Access Compliance Report

Public Rights-of-Way (Curb Ramps)

Intersection ID: 2509	Main Street: LYNNEWOOD_GLEN_DR	Cross Street: WHITEGATE_LN	Location: SW
ADA ID: 88F98A9D9C5F	Ramp Type: PerpDiag	Initial Pass/Fail: Fail	Overall Compliance: No
Severity Score: 22.5			
Codes/Mitigation Info/Possible Solution		Field Measurements/Component Compliance

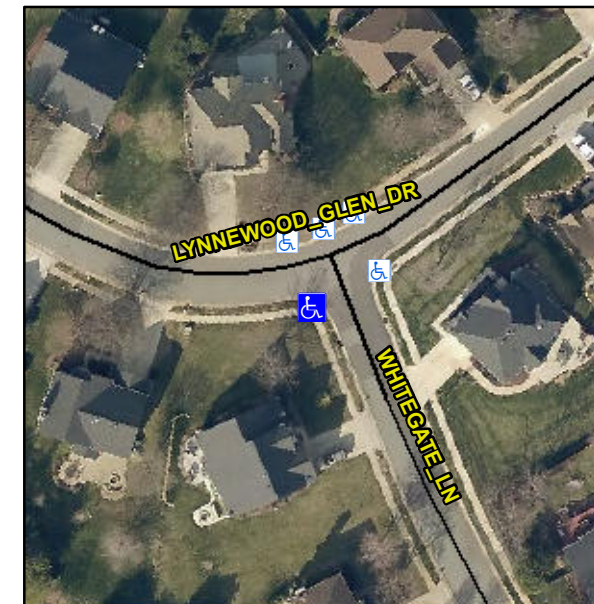
Not Found, R304.5.1, R304.2.2, R304.5.3

Compliance	Description	Data	Compliance	Description	Data
N/A	Ramp Length (in)	46.0	No	Ramp Slope (%)	10.4
No	Ramp Width (in)	42.0	No	Ramp XSlope (%)	4.4
N/A	Flare Type LT	N/A	N/A	Flare Type RT	N/A
N/A	Flare Slope LT (%)	N/A	N/A	Flare Slope RT (%)	N/A
N/A	Flare Traversable LT?	N/A	N/A	Flare Traversable RT?	N/A
N/A	Landing Length (in)	N/A	N/A	DWS Provided?	N/A
N/A	Landing Width (in)	N/A	N/A	DWS Contrast?	N/A
N/A	Landing Slope (%)	N/A	N/A	DWS Length (in)	N/A
N/A	Landing X Slope (%)	N/A	N/A	DWS Full Width?	N/A
N/A	Landing Curb? (Y/N)	N/A	N/A	DWS Offset (in)	N/A
N/A	Shared Landing?	N/A			
N/A	Gutter Ponding?	N/A	N/A	Gutter Slope (%)	N/A
N/A	Gutter Lip Ht (in)	N/A	N/A	Gutter X Slope (%)	N/A
N/A	Painted X Walk1?	No	N/A	Painted X Walk2?	No
	X Walk 1 Direction	To E		X Walk 2 Direction	To N
N/A	X Walk 1 Width (in)	N/A	N/A	X Walk 2 Width (in)	N/A
	X Walk 1 Slope (%)	1.2		X Walk 2 Slope (%)	1.3
	X Walk 1 X Slope (%)	3.2		X Walk 2 X Slope (%)	0.5

N/A	Ramp inside XWalk1?	N/A	N/A	Ramp inside XWalk2?	N/A
	Road Slope (%)	0.0	N/A	Clear Space?	N/A
	Road X Slope (%)	2.9	N/A	Clear Space to XWalk (in)	N/A
N/A	Any Obstructions?	N/A	N/A	Storm Grate/Utility Hazard?	N/A
	Obstruction Type			Storm Grate/Utility Type	
		N/A			N/A
			Yes	Surface Condition? (G/P)	Good

Remove & Replace Curb Ramp With Two New Directional Ramps or Equivalent.
